## FREDERICK COUNTY PLANNING COMMISSION

**TITLE:** **Stups Market** – Proposed Gas Pumps and Canopy

**FILE NUMBER:** **SP 10-10** (AP#'s 11047, 11447 & 11051)

**REQUEST:** **Concept and Site Plan Approval** (Requesting approval for new gas pumps and canopy; landscaping and parking modifications; and APFO & FRO approval)

## PROPOSED GAS CANOPY ELEVATION ILLUSTRATION

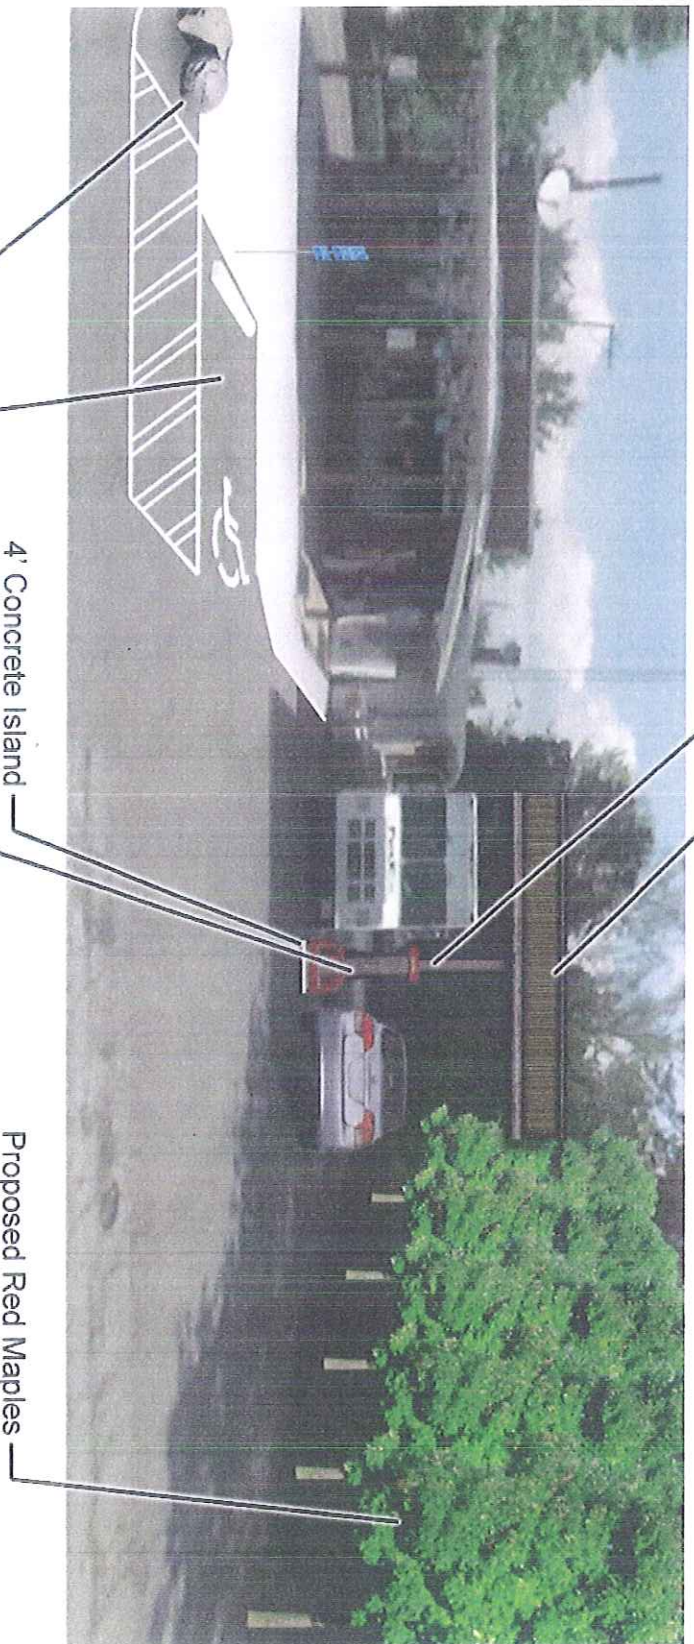
commercial properties, including the store (originally Gochnaur's), the bank, and several warehouses along the railroad. (The latest) submission does not show enough detail of the proposed canopy and gas pump island. (It is unclear) where ...the cited "brick accents to match existing store" (are) to be used?...The cut and paste illustration does not provide enough clear detail."

"The edging of the canopy is apparently shown as brick or brick veneer in the plans. This is an incongruous choice of material. It sets up a visual improbability: a brick slab held up in the air by thin columns. The Applicant (should) reconsider that choice and just use a very plain edging fascia."

- 4) Work with the Historic Preservation Planner to design a canopy design that is more compatible with the historic infrastructure and designs of the surrounding community.
